COMMUNITY DEVELOPMENT DEPARTMENT REPORT

HEARING DATE: 3/5/2026
TO: Planning & Zoning Commission
FROM: Nick Napoli, Associate Planner
208-884-5533
nnapoli@meridiancity.org
APPLICANT: David Ruby
SUBJECT: H-2025-0040
Rolling Hills

LANDSCAPE PLAN - AREA 2

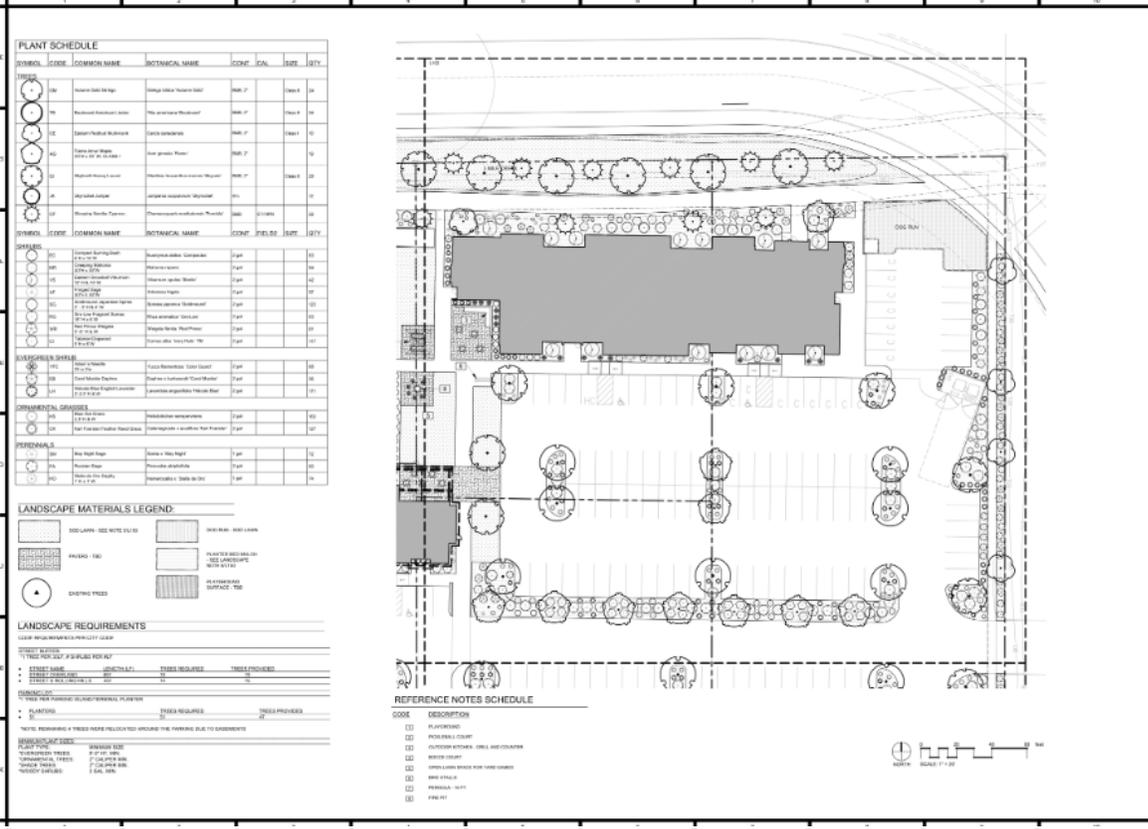
The proposed landscape plan meets this requirement. However, the vegetation coverage appears to be below the 70% required at maturity. If approved, these calculations shall be submitted with the certificate of zoning compliance application.

The applicant does not meet the pathway landscaping requirements and shall revise their site and landscape plan to reflect compliance with the vegetation coverage standards.
